Product/Process Change Notice - PCN 14_0178 Rev. -

PCN Title: Conversion of 3x3mm, 4x4mm and 5x5mm LFCSP Package Outlines from Punch to Sawn and Transfer of Assembly Site to Amkor Philippines

Publication Date: 03-Oct-2014

Package Outline Drawing (5x5mm)

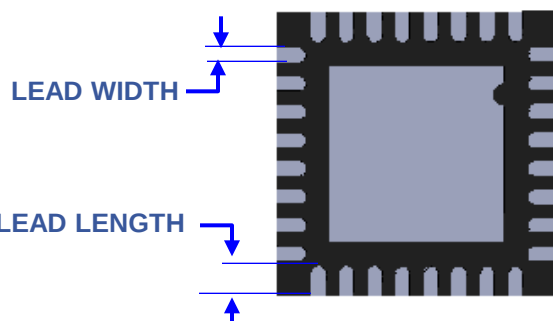
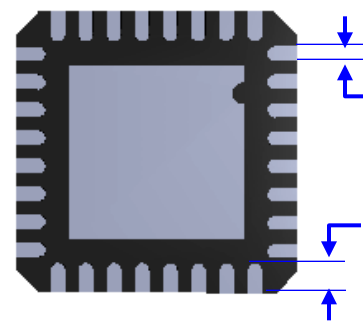
Package Thickness Difference

Exposed Pad, Lead Length and Lead Width dimensions remains within tolerance.

Body Size (mm)	Lead Count	FROM: Punch Type LFCSP				TO: Sawn Type LFCSP			
		POD Spec	E-Pad Size (mm SQ.)	Lead Length (mm)	Lead Width (mm)	POD Spec	E-Pad Size (mm SQ.)	Lead Length (mm)	Lead Width (mm)
5x5	32	CP 32-2	3.1 ± 0.15	0.40 ± 0.15	0.25 ^{+0.05} _{-0.07}	CP 32-7	3.1 ± 0.15	0.40 ± 0.10	0.25 ^{+0.05} _{-0.07}

Package Dimensions (4x4mm)

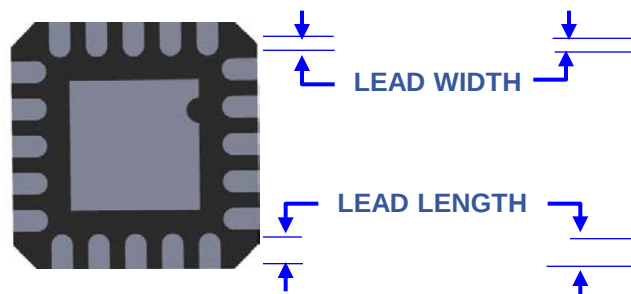
Package Thickness Difference

Exposed Pad, Lead Length and Lead Width dimensions remains within tolerance.

Body Size (mm)	Lead Count	Punch Type LFCSP				Sawn Type LFCSP			
		POD Spec	E-Pad Size (mm SQ.)	Lead Length (mm)	Lead Width (mm)	POD Spec	E-Pad Size (mm SQ.)	Lead Length (mm)	Lead Width (mm)
4x4	16	CP 16-4	2.3 ± 0.15	0.60 ^{+0.15} _{-0.10}	0.30 ±0.05	CP 16-23	2.3 ± 0.15	0.60 ± 0.10	0.30 ±0.05
		CP 16-10	2.35 ± 0.15	0.40 ±0.10	0.30 ±0.05	CP 16-20	2.35 ±0.10	0.40 ±0.10	0.30 ±0.05
		CP 16-13	2.5 ± 0.15	0.40 ±0.10	0.23 ^{+0.07} _{-0.05}	CP 16-26	2.5 ±0.10	0.40 ±0.10	0.30 ±0.05
4x4	24	CP 24-3	2.5 ± 0.15	0.40 ±0.10	0.23 ^{+0.07} _{-0.05}	CP 24-7	2.5 ± 0.15	0.40 ±0.10	0.25 ^{+0.05} _{-0.07}

Package Dimensions (3x3mm)

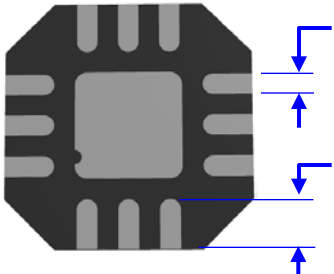
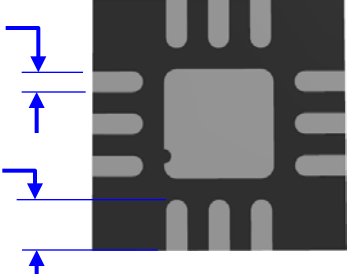
PUNCH	SAWN	
 0.85mm	 0.75mm	Package Thickness Difference
 LEAD WIDTH LEAD LENGTH		Exposed Pad, Lead Length and Lead Width dimensions remains within tolerance.

Body Size (mm)	Lead Count	Punch Type LFCSP				Sawn Type LFCSP			
		POD Spec	E-Pad Size (mm SQ.)	Lead Length (mm)	Lead Width (mm)	POD Spec	E-Pad Size (mm SQ.)	Lead Length (mm)	Lead Width (mm)
3x3	12	CP 12-3	1.5 ± 0.15	0.60 ^{+0.15} _{-0.10}	0.23 ^{+0.07} _{-0.05}	CP 12-5	1.5 ± 0.15	0.40 ± 0.10	0.23 ^{+0.07} _{-0.05}
3x3	16	CP 16-2	1.3 ± 0.15	0.40 ± 0.10	0.23 ^{+0.07} _{-0.05}	CP 16-21	1.3 ± 0.15	0.40 ± 0.10	0.23 ^{+0.07} _{-0.05}
		CP 16-3	1.5 ± 0.15	0.40 ± 0.10	0.23 ^{+0.07} _{-0.05}	CP 16-27	1.5 ^{+0.15} _{-0.05}	0.40 ± 0.10	0.25 ^{+0.05} _{-0.07}
